7 March 2025

Our Ref: P222_481-1 (ACCESS DA) DV

**ACCESSIBILITY CAPABILITY STATEMENT FOR SSDA SUBMISSION
PROJECT NAME: 3-5 HELP STREET, CHATSWOOD**

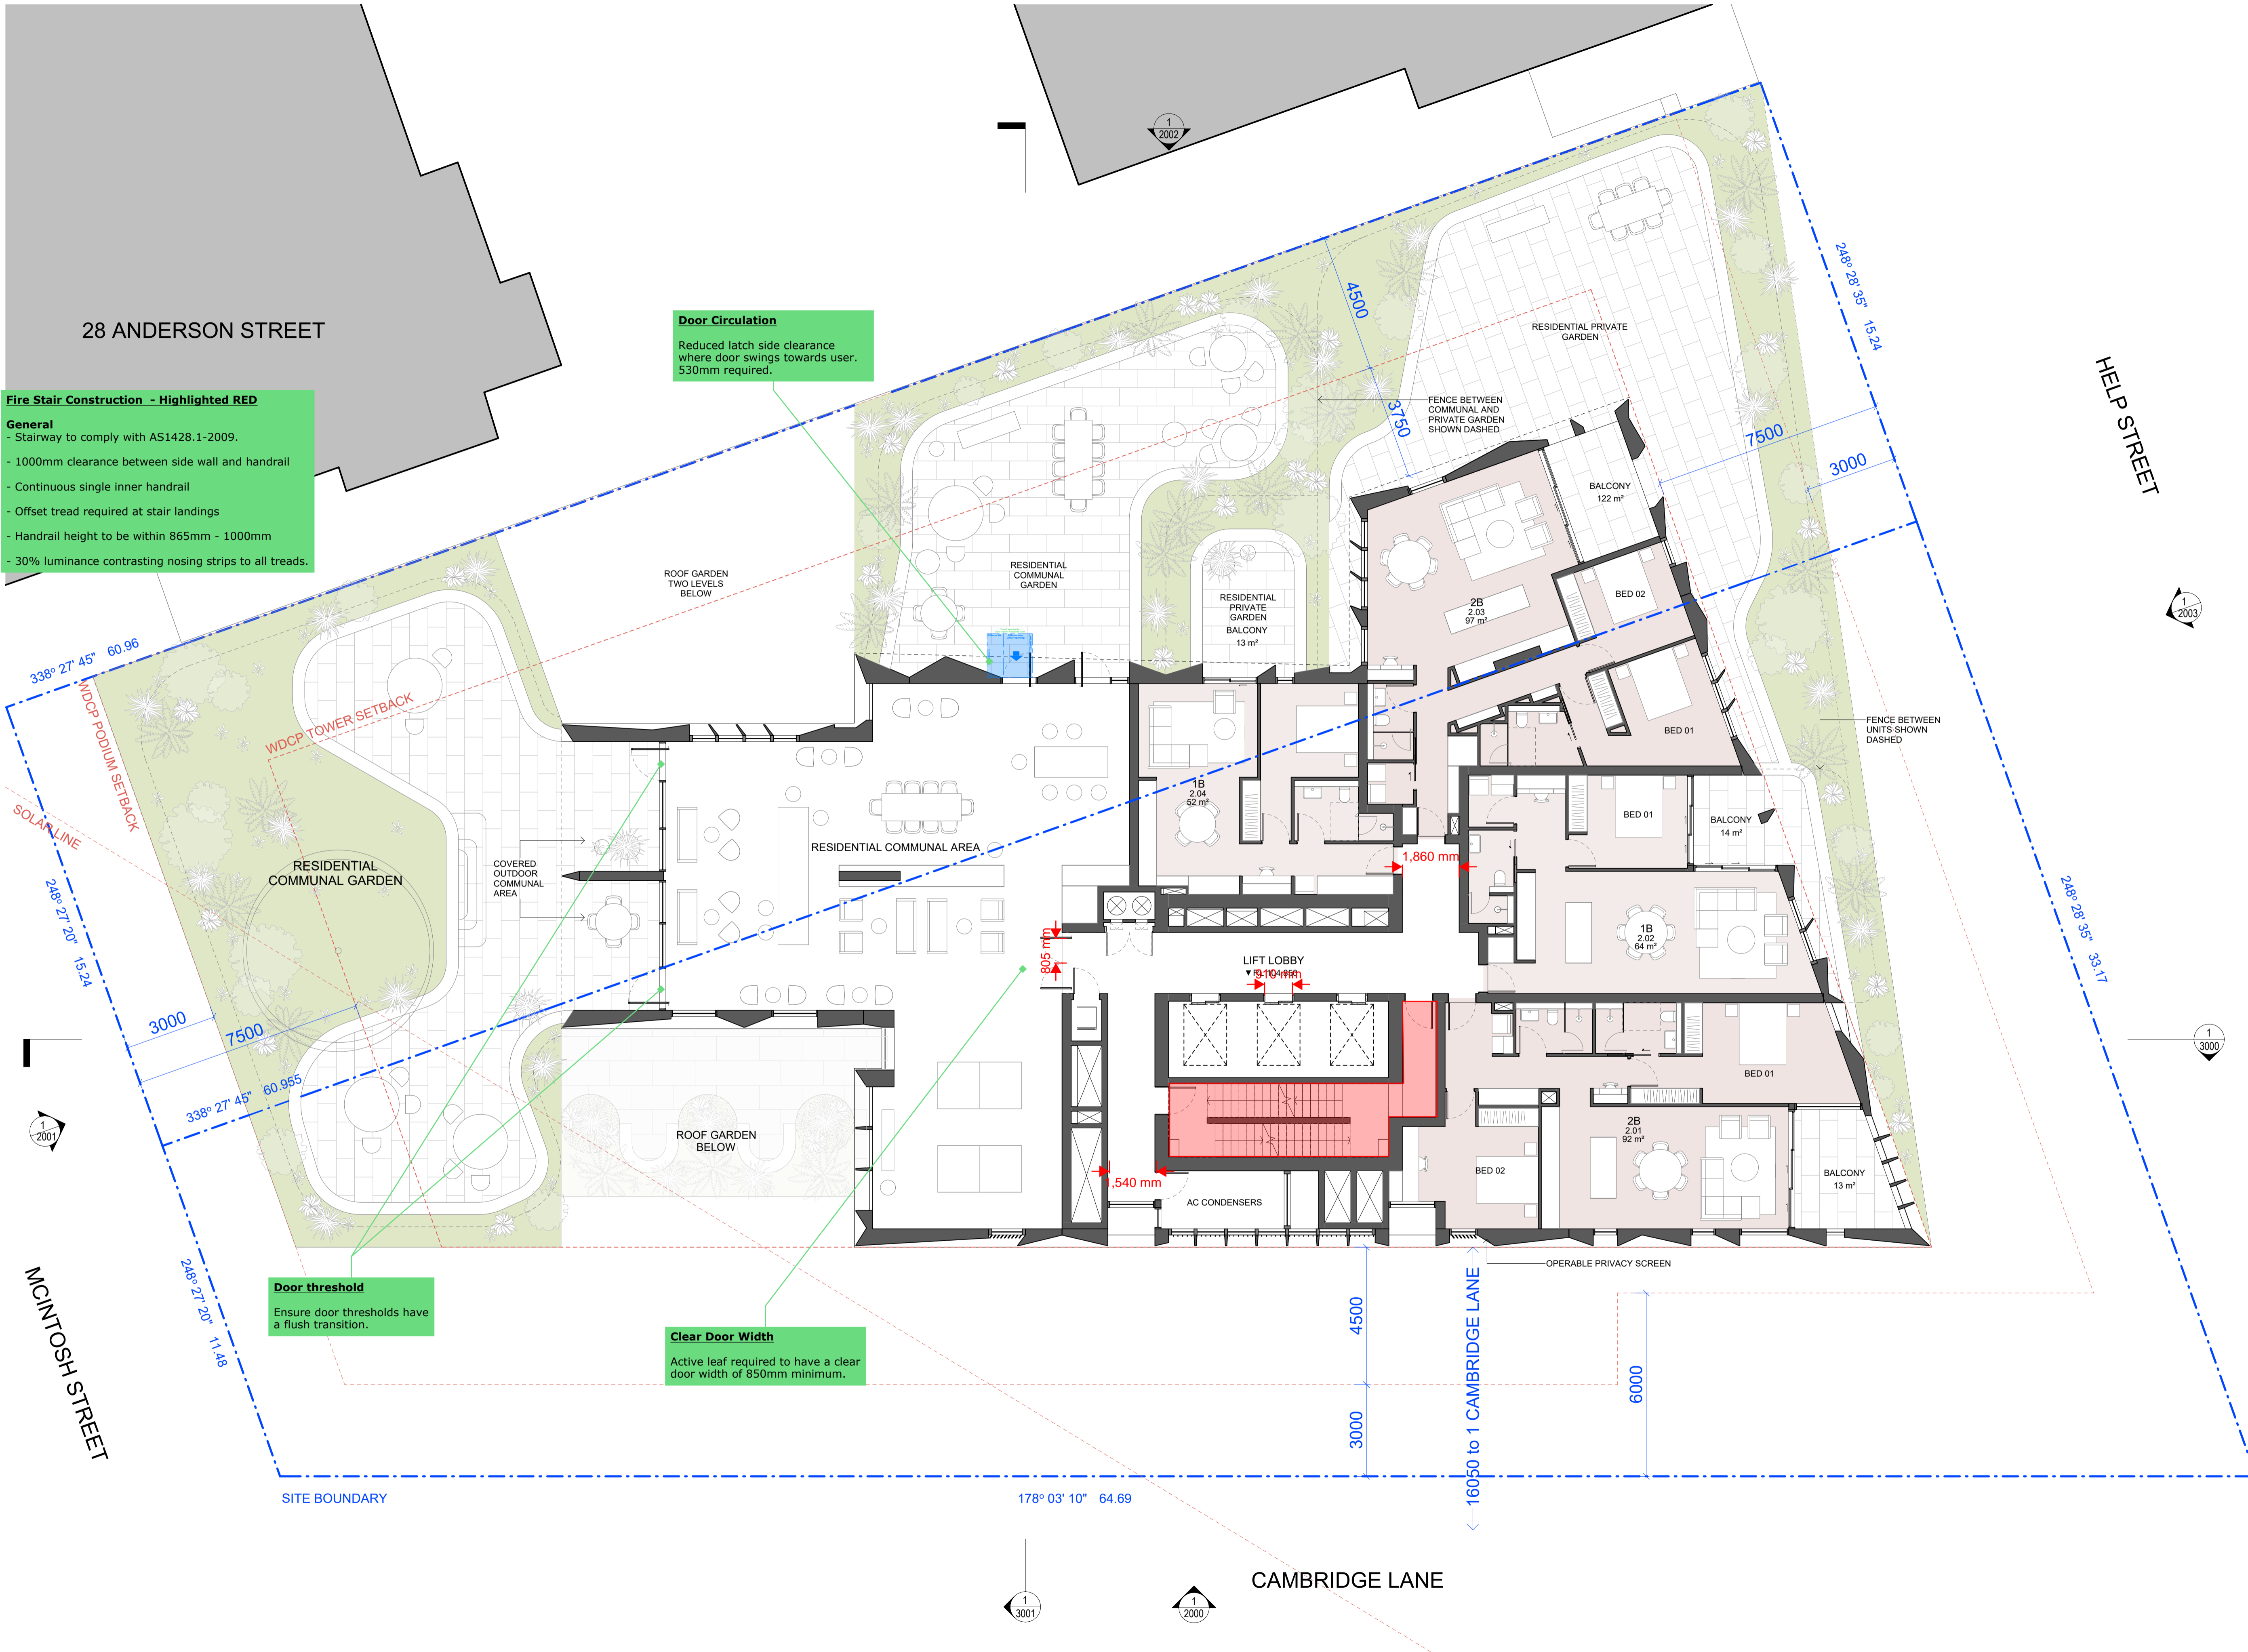
Reduced latch side clearance where door swings towards user. 530mm required.

Ensure door thresholds have a flush transition.

Active leaf required to have a clear door width of 850mm minimum.
